MEMORANDUM

Re: Comments following S92 response

OceanaGold are seeking to extend the mine footprint associated with the Coronation Project. The existing project operates in the headwaters of Camp Creek, with the proposed new operation expanding into the Mare Burn catchment. As part of the consent process Otago Regional Council sought additional information from OceanaGold. The following are the four specific items that additional information was sought as part of the Resource Science Unit:

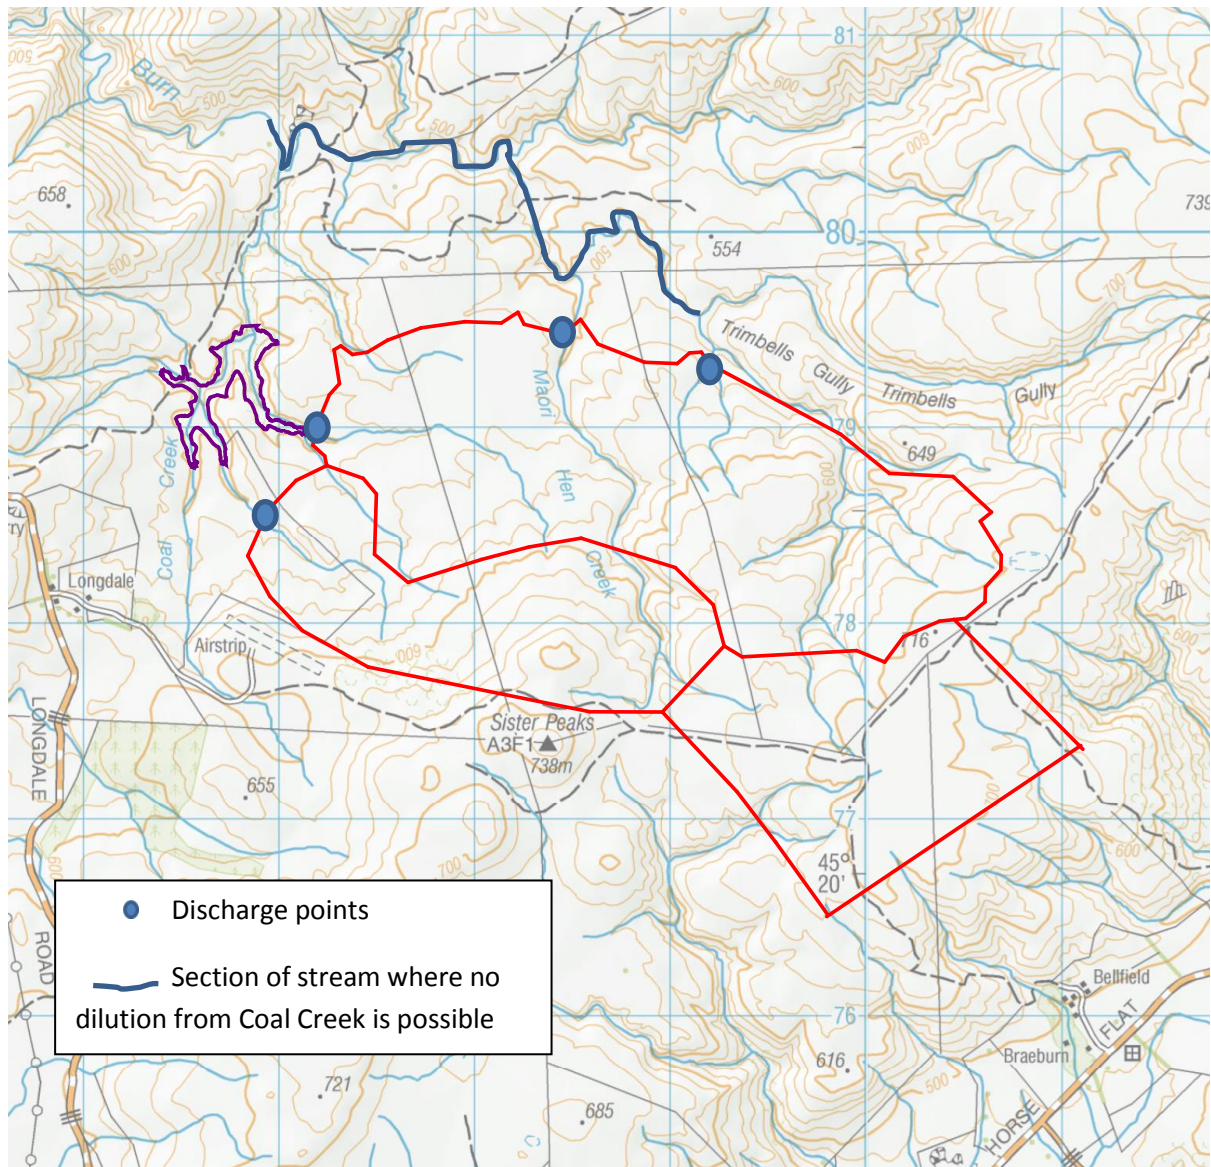
There is still the section of Trimbells Gully where no dilution from Coal Creek is possible, as highlighted in the above map.

The upper reaches of Maori Hen Creek are mostly within the footprint of the planned Coronation North Pit. The stretch of Maori Hen Creek between the pit and its confluence with Trimbells Gully is to be infilled with the Coronation North WRS. In addition, OceanaGold plans to install a silt dam in the Maori Hen Creek gully between the toe of the Coronation North WRS and the confluence with Trimbells Gully. On that basis, there will be no remaining free-flowing stretch of Maori Hen Creek once the Coronation North Project has been completed.

The water quality in Trimbells Gully upstream from the main WRS seepage location (Figure 1) is not expected to be affected by mine water discharges from the Coronation North Project. The water quality in Trimbells Gully and in Mare Burn for the stretch between the main WRS seepage location and the proposed compliance point MB02 will be affected by seepage discharges from Coronation WRS. Measures planned by OceanaGold to avoid, mitigate or remedy the effects of these discharges include:

- The installation of silt dams at the toe of the WRS in Maori Hen Creek and at the main WRS seepage location (Figure 1) to reduce the discharge of suspended solids from the WRS to Trimbells Gully during the operational period of the mine.
- The rehabilitation of the WRS to reduce the discharge of suspended solids from the WRS to the silt dams following mine closure.
- Iron and arsenic carried in solution in discharges from Coronation North WRS are expected to precipitate out in or upstream from the silt ponds at the WRS toe. This process has been observed at the existing silt ponds on site.
